Well Name: QPBSSU	Well Location: T18S / R32E / SEC 26 / TR 12D / NENW /	County or Parish/State: LEA / NM
Well Number: 12D-2	Type of Well: INJECTION - ENHANCED RECOVERY	Allottee or Tribe Name:
Lease Number: NMNM40452	Unit or CA Name: QUERECHO PLAINS BONE SPG	Unit or CA Number: NMNM88523X
US Well Number: 3002524564	Well Status: Water Injection Well	Operator: MEWBOURNE OIL COMPANY

Notice of Intent

PLUG AND ABANDONMENT CONDITIONS OF APPROVAL

OPERATOR'S NAME:	Mewbourne Oil Company
LEASE NO.:	NMNM40452
WELL NAME & NO.:	QPBSSU 12D-2
US Well Number:	3002524564
LOCATION:	Section 26, T.18 S., R.32 E., NMPM
COUNTY:	Lea County, New Mexico
Sundry ID:	2773821
Karst:	☒ Low ☐ Medium ☐ High ☐ Critical
Potash:	☐ Secretary ☐ R111P
Special Area:	☐ Prairie Chicken ☒ Capitan Reef

QPBSSU 12D-2 P&A Schematic

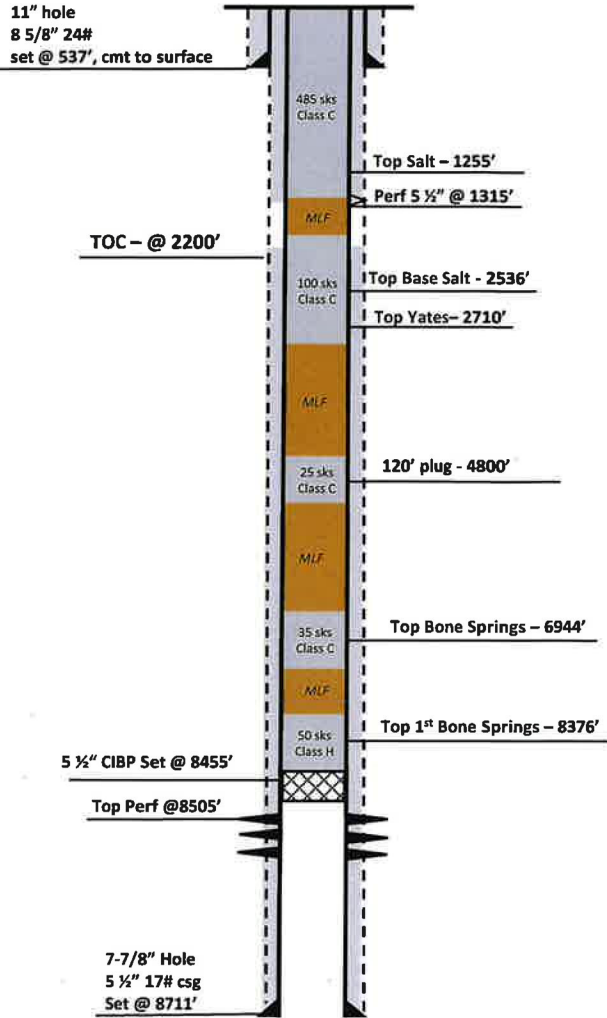
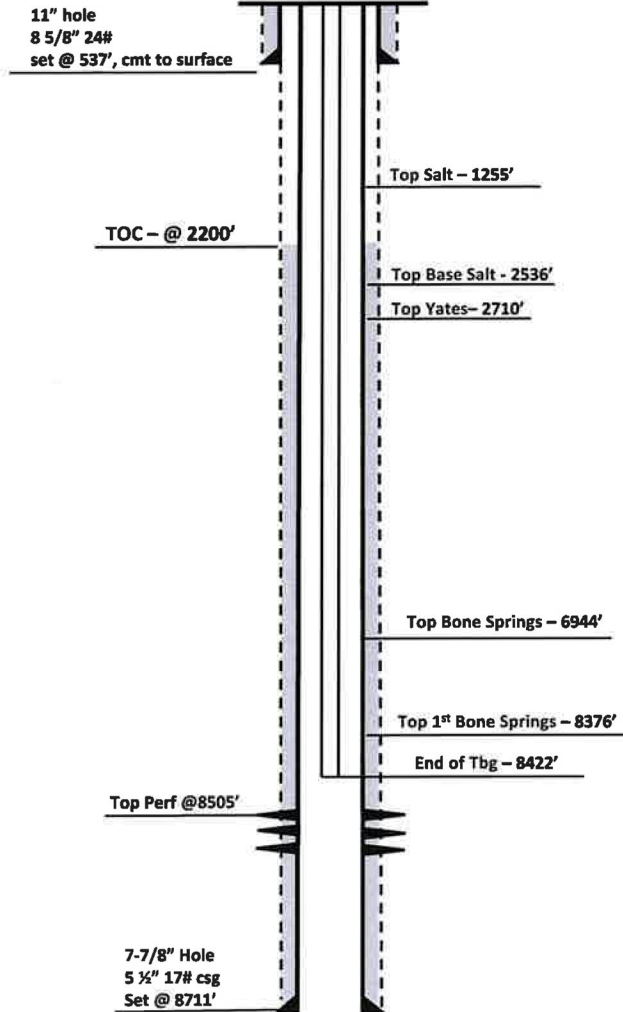
- 1) POOH laying down 2-7/8" tbg.
- 2) Set CIBP at 8455'. Leak test CIBP. Spot 25 sxs Class H on top. Run CBL from top of cement to surface.
- 3) Spot cement from 6990' to 6820'. 25 sxs Class C.
- 4) Spot cement from 4723' to 3823'. 89 sxs Class C.
- 5) Spot 30 sxs from 2760' to 2460'. If no cement behind casing, perf and squeeze instead, WOC and Tag. (In 30 sxs/Out 40 sxs)
- 6) Spot 25 sxs from 1305' to 1192'. If no cement behind casing, perf and squeeze instead, WOC and Tag. (In 12 sxs/Out 15 sxs)
- 7) Spot 59 sxs from 587' to surface. If no cement behind casing, perf and squeeze instead, WOC and Tag. (In 59 sxs/Out 86 sxs)
- 7) ND BOP and cut off wellhead 5' below surface. RDMO PU, transport trucks, and pump truck.
- 8) Set P&A marker.

Sundry ID		2773821					
Plug Type	Top	Bottom	Length	Tag	Sacks	Cement Class	Notes
Surface Plug	0.00	100.00	100.00	Tag/Verify			
8.625 inch- Shoe Plug	481.63	587.00	105.37	Tag/Verify	59.00	C	Spot 59 sxs from 587' to surface. If no cement behind casing, perf and squeeze instead, WOC and TAG. (In 59 sxs/Out 86 sxs)
Top of Salt @ 1255	1192.45	1305.00	112.55	Tag/Verify	25.00	C	Spot 25 sxs from 1305' to 1192'. If no cement behind casing, perf and squeeze instead, WOC and Tag. (In 12 sxs/Out 15 sxs)
Base of Salt @ 2536	2460.64	2586.00	125.36	Tag/Verify			
Yates @ 2710	2632.90	2760.00	127.10	If solid base no need to Tag (CIBP present and/or Mechanical Integrity Test), If Perf & Sqz then Tag, Leak Test all CIBP if no Open Perforations	30.00	C	Spot 30 sxs from 2760' to 2460'. If no cement behind casing, perf and squeeze instead, WOC and Tag. (In 30 sxs/Out 40 sxs)
Queen @ 3913	3823.87	3963.00	139.13	If solid

Capitan Reef @ 4472	4377.28	4522.00	144.72	If solid			
Delaware @ 4673	4576.27	4723.00	146.73	If solid base no need to Tag (CIBP present and/or Mechanical Integrity Test), If Perf & Sqz then Tag, Leak Test all CIBP if no Open Perforations	89.00	C	Spot cement from 4723' to 3823'.

If solid base no need to Tag (CIBP present and/or Mechanical Integrity Test), If Perf & Sqz then Tag, Leak Test all CIBP if no Open Perforations			
Bonesprings @ 6940	6820.60	6990.00	169.40	ns	25.00	C	Spot cement from 6990' to 6820'.
				If solid base no need to Tag (CIBP present and/or Mechanical Integrity Test), If Perf & Sqz then Tag, Leak Test all CIBP if no Open Perforations			
CIBP Plug	8420.00	8455.00	35.00	ns	25.00	H	Set CIBP at 8455'. Leak Test CIBP. Spot 25 sxs on top. Run CBL from top of cement to surface.
Perforations Plug (If No CIBP)	8438.26	8624.00	185.74	Tag/Verify			
5.5 inch- Shoe Plug	8573.89	8761.00	187.11	Tag/Verify

Created By	Condition	Condition Date
gcordero	Run CBL 8455' to 500' above TOC. CBL must be submitted to OCD via OCD permitting	3/20/2024
